A SET OF CONSTRUCTION PLANS FOR CIVIC PARK IMPROVEMENTS

CONDITIONS OF APPROVAL FROM PLANNING AND ZONING

CIVIC PARK IMPROVEMENTS
O'Fallon Parks and Rec
Civic Park, O'Fallon,
Missouri

Page No.
C0-00

Plan View

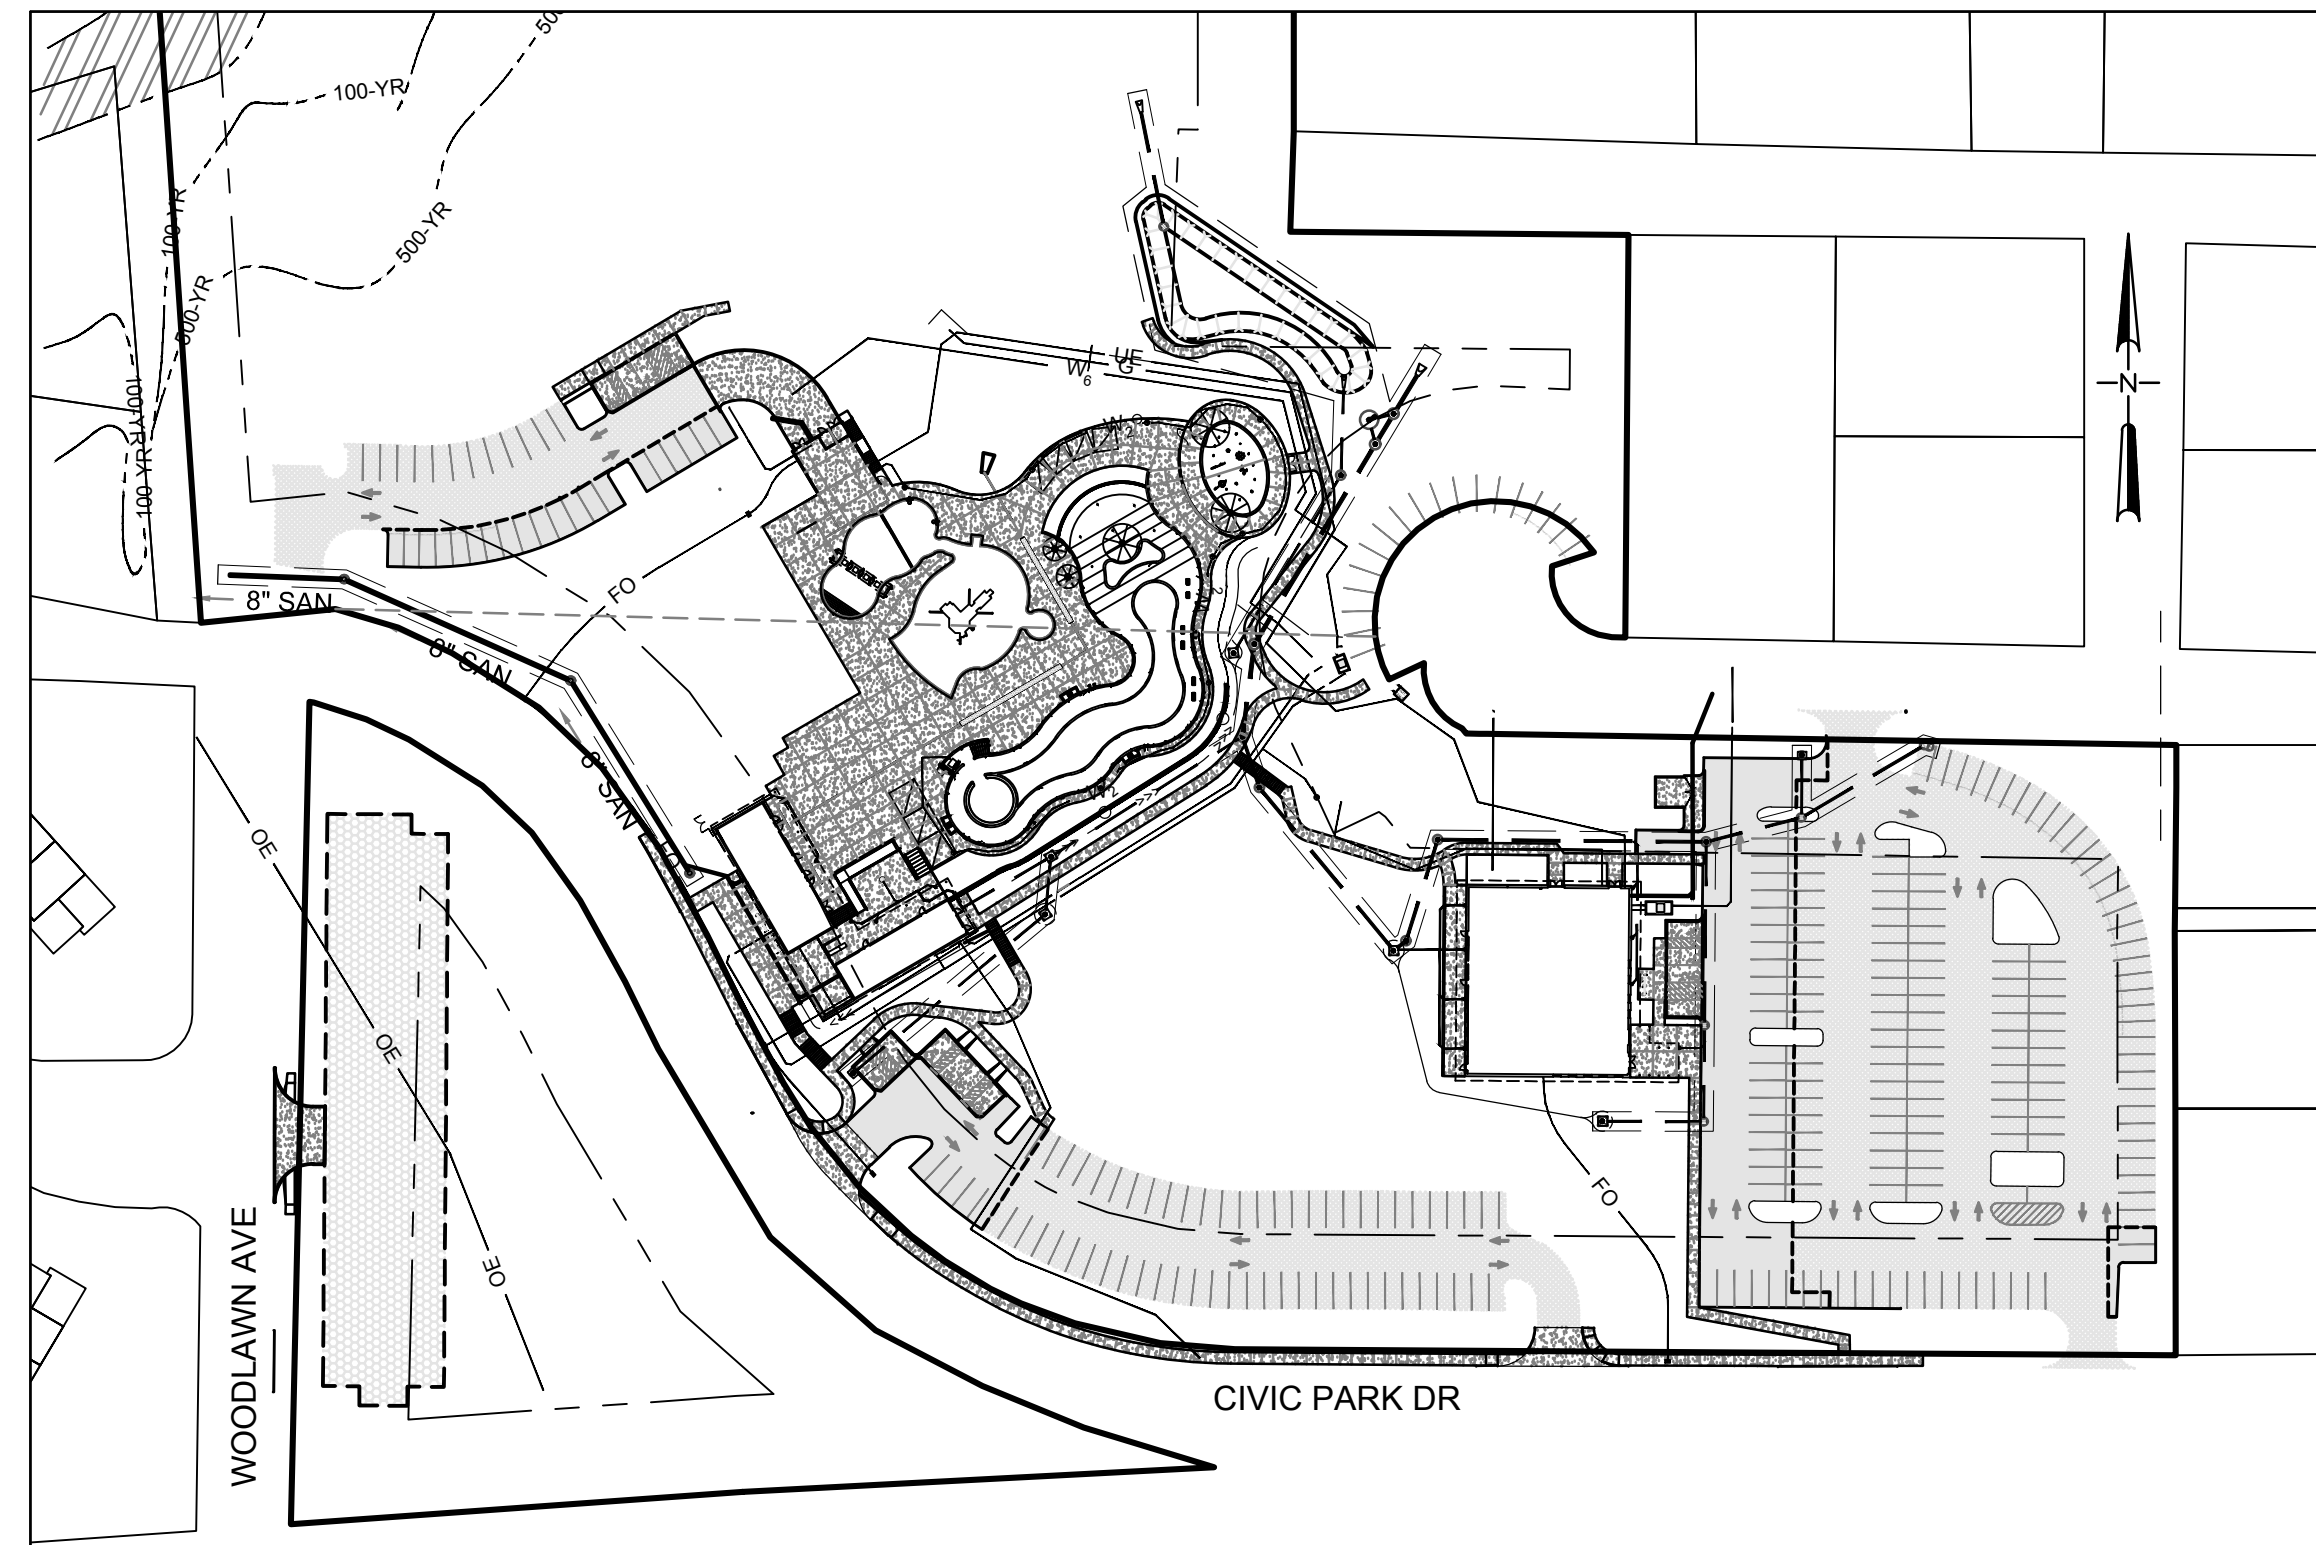
- PROVIDE ADDITIONAL DETAILS ON THE PROPOSED PLAYGROUND REGARDING WHETHER THIS IS A RELOCATION OF EXISTING EQUIPMENT OR NEW FEATURES.
- WORK WITH STAFF ON THE CONFIGURATION OF THE ENTRANCE OF THE PROPOSED WOODLAWN AVENUE PARKING LOT.

- THE BATHHOUSE AND CONCESSION STAND SHOWN ON THE SITE PLAN DO NOT MATCH THE BUILDING ELEVATIONS, WHICH SHOWS A BREEZEWAY CONNECTING THE TWO BUILDINGS. WORK WITH CITY STAFF TO RESOLVE THE DISCREPANCY ON THE PLAN. IF THERE IS AN ADDITIONAL ENCROACHMENT INTO THE BUILDING SETBACK, A VARIANCE WILL BE REQUIRED.

- THE TRASH ENCLOSURE IS ENCRUCHING OVER THE 60 FOOT FRONT YARD BUILDING SETBACK BY APPROXIMATELY FORTY FEET. THE STRUCTURE SHALL BE MOVED TO MEET THE SETBACK OR A VARIANCE WILL BE REQUIRED.

- PROVIDE PARKING LOT LANDSCAPING IN PLACE OF THE PROVIDED AREAS WITH PAINTED STRIPING.
- THE CONCRETE WALK NEAR THE WESTERN ENTRANCE OF THE MIDDLE PARKING LOT IS SHOWN CONNECTING AT THE RAMP LOCATION. WORK WITH STAFF ON THIS CONFIGURATION.
